MTF ILdd Revisited

D2.3 comment #85

Introduction – comment #85 from D2.3

Figure 179B-2—Mated test fixtures insertion loss

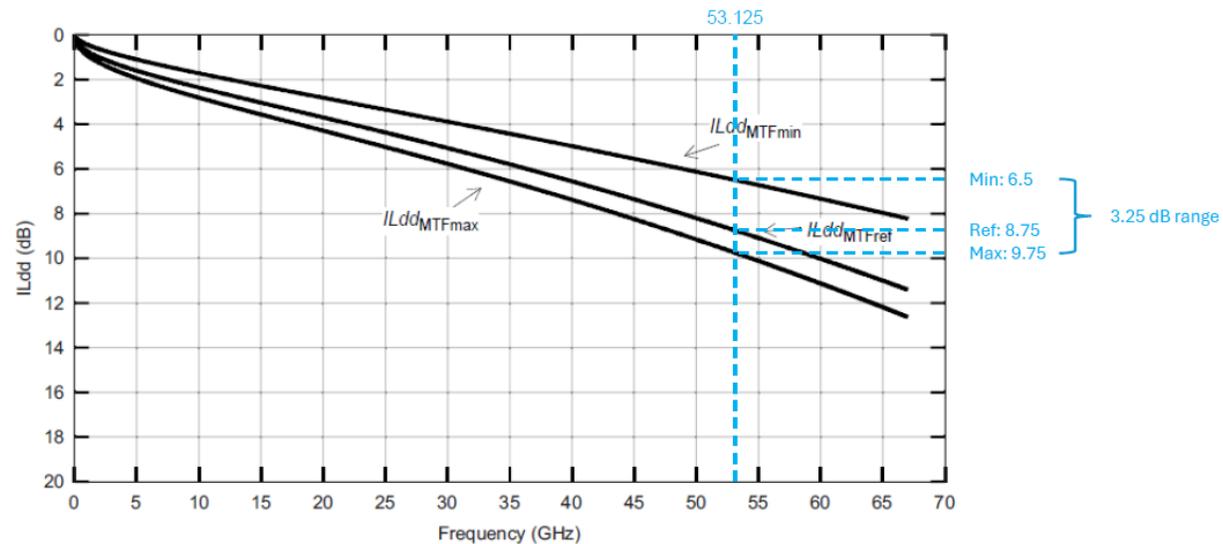
<i>CI</i> 179B	<i>SC</i> 179B.4.1	<i>P</i> 912	<i>L</i> 10	# 85
Ran, Adee		Cisco Systems		
<i>Comment Type</i>	T	<i>Comment Status</i>	R	<i>Test fixtures (E)</i>
The difference between minimum and maximum ILdd for mated test fixtures is about 3 dB at the Nyquist frequency. This difference allows significant variations in cable assembly test fixture (MCB), which can have a double effect (up to 6 dB) if used to measure a cable.				
<i>SuggestedRemedy</i>				
Reduce the allowed variability of test fixtures, or its effect on measurements. A detailed proposal is planned.				
<i>Response</i>		<i>Response Status</i>	C	
REJECT. This comment does not apply to the substantive changes between IEEE P802.3dj D2.2 and D2.3. However, the commenter indicated that it is related to unsatisfied comment #306 against D2.2 (see < https://www.ieee802.org/3/dj/comments/D2p2/8023dj_D2p2_comments_final_id.pdf#page=84 >), so it is considered in scope. The CRG has reviewed the following contributions: < https://www.ieee802.org/3/dj/public/26_01/ran_3dj_02_2601.pdf > < https://www.ieee802.org/3/dj/public/26_01/mammenga_3dj_01_2601.pdf > Note the the draft states that "The effects of differences between the insertion loss of an actual test fixture and the reference insertion loss are to be accounted for in the measurements". The comment suggests changes that are a potential improvement, but the specific details are not clear. The discussion did not show consensus for any of the directions in the presentation. Future work and consensus building on this topic are encouraged. There was no consensus to make a change.

<i>CI</i> 179B	<i>SC</i> 179B.4.2	<i>P</i> 905	<i>L</i> 20	# 306
Noujeim, Leesa		Google		
<i>Comment Type</i>	TR	<i>Comment Status</i>	R	<i>test fixtures (E)</i>
lidd_MTFmin is, at fNyquist, 4dB lower than lidd_MTFmax. This large allowed variation in MTF IL introduces too much uncertainty as to whether a given DUT (host or cable assembly) passes or fails due to variation in the test fixture.				
<i>SuggestedRemedy</i>				
Decrease the spread between ILddMTFmin and ILddMTFmax to ~2dB, by adjusting equations 179B-3 and 179B-4.				
<i>Response</i>		<i>Response Status</i>	U	
REJECT. The comment identifies an area for potential improvement in the current draft. However, the suggested remedy does not provide sufficient detail to implement. A contribution with a detailed proposal would be helpful for the CRG to drive consensus on a specific change.

Mated Test Fixture (MTF) ILdd

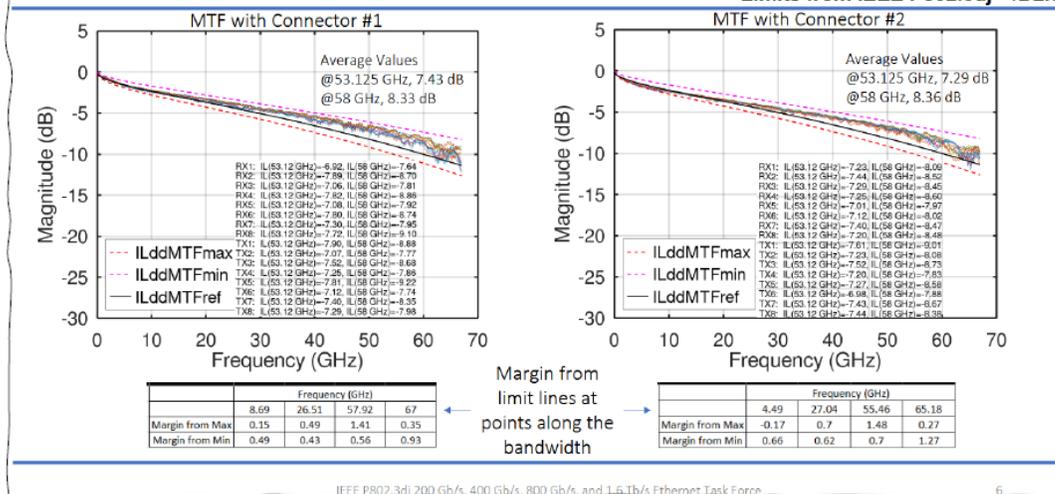
Variation between lanes on the same MTF is significant – at 53.125 GHz, 0.98 dB for “connector #1”, 0.69 dB for “connector #2”. There is a larger variation above 53.125 GHz

The differences seem mainly in the ripple.

The range can be tightened somewhat by raising the “max” line (and the reference line)... But this might coincide with manufacturing variations and yield

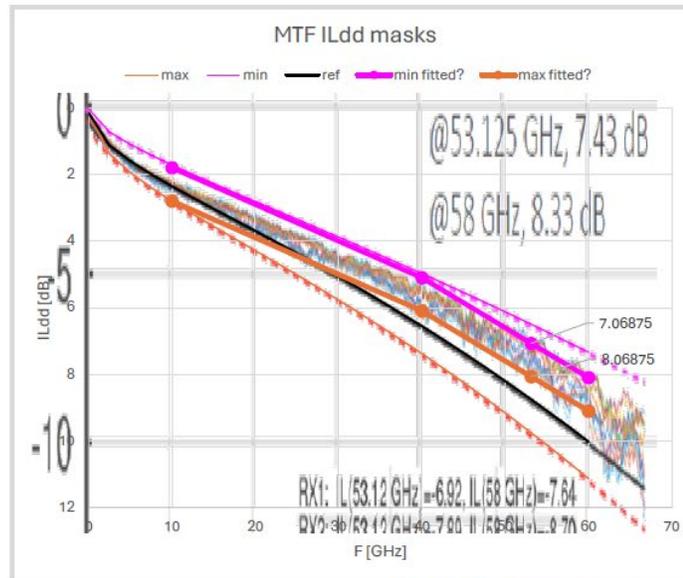
- One direction is to reduce variability, but without causing actual test fixtures to fail
- Since the ripple is limited by another specification (FOM_{ILD}) we can apply a tighter mask to the **fitted** ILdd (which should be less variable)
- The following piecewise-linear equations (with ± 0.5 dB tolerance) create a possible mask based on the Mammenga dataset:

- Min fitted ILdd:
$$\begin{cases} 1.8 + 0.11(f - 10) & 10 < f \leq 40 \\ 5.1 + 0.15(f - 40) & 40 < f \leq 60 \end{cases}$$
- Max fitted ILdd:
$$\begin{cases} 2.8 + 0.11(f - 10) & 10 < f \leq 40 \\ 6.1 + 0.15(f - 40) & 40 < f \leq 60 \end{cases}$$

Example fitted ILdd masks

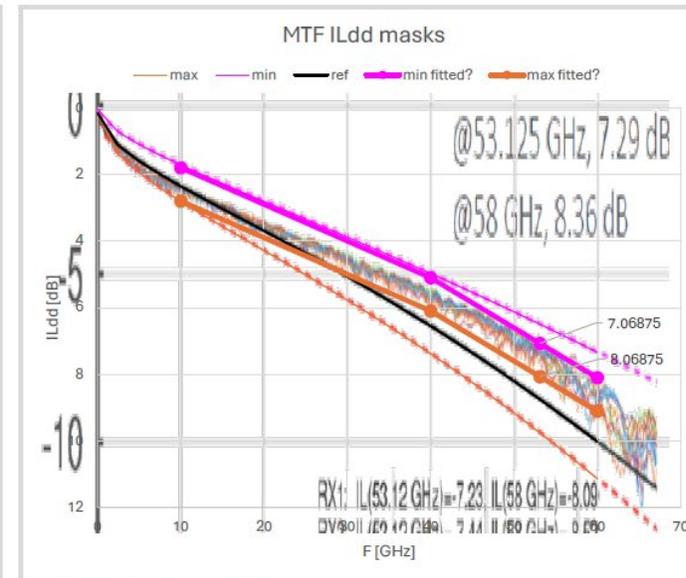
Mask overlaid on "MTF with Connector #1" plots

Mask overlaid on "MTF with Connector #2" plots
